DEVELOPMENT REVIEW BOARD REPORT

Asian Bistro 7-DR-2017

Location: 10225 & 10227 North Scottsdale Road

Request: Request approval of the site plan, landscape plan, and building elevations for a new, two-story restaurant, in approximately 3,972 square feet of building area, with approximately 1,795 square feet of outdoor dining area, all on an approximately 0.11-acre site.

PROPOSED SITE PLAN
 PRELIMINARY SITE PLAN, DETAILS AND NOTES

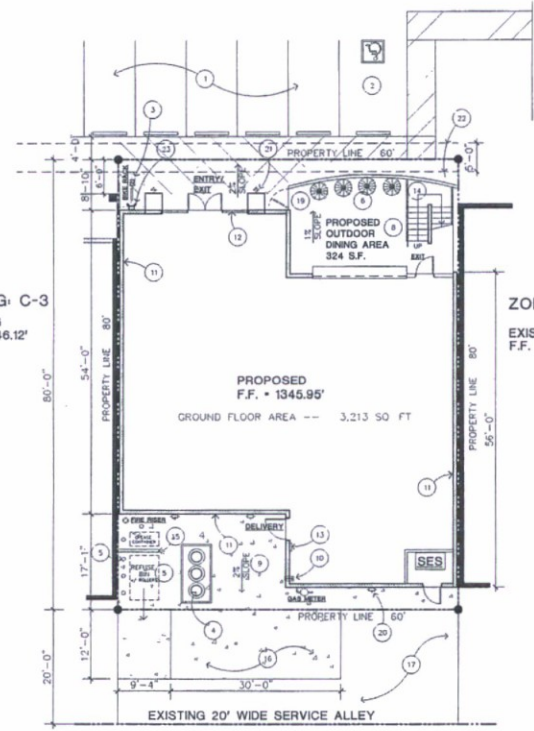
11. *With the improvement plan submittal, the property owner shall revise the location of the new bike racks to a location that does not conflict with FDC location for building, to the satisfaction of Planning and Fire plans review staff.*
